Block 1 Section 38 Wright – First Session

KOKO Lease C

## THE PANEL'S ADVICE

Date issued: Tuesday 23 February 2022

Above: Elevations  
Below: Perspectives

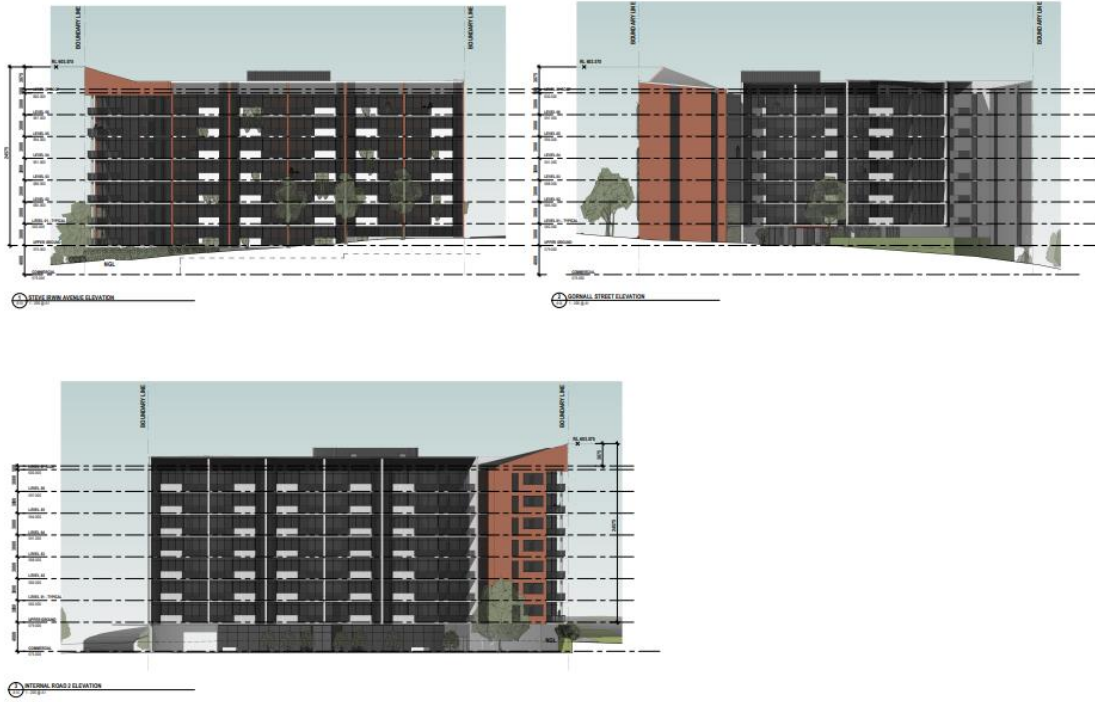
7.1 In relation to materiality, while the Panel is supportive in-principle of use of face brick, the current application is observed to have a 'thinness' that is incongruous with the nature of the material. The proponent is encouraged by the Panel to ensure that any proposed use of brick is genuine brick and that the application of the material is used to develop a visual relationship to the adjacent townhouses (e.g. through application of brick up to a certain common height datum). In this regard the Panel notes an opportunity to use high quality materials to establish a unique identity for the proposal.
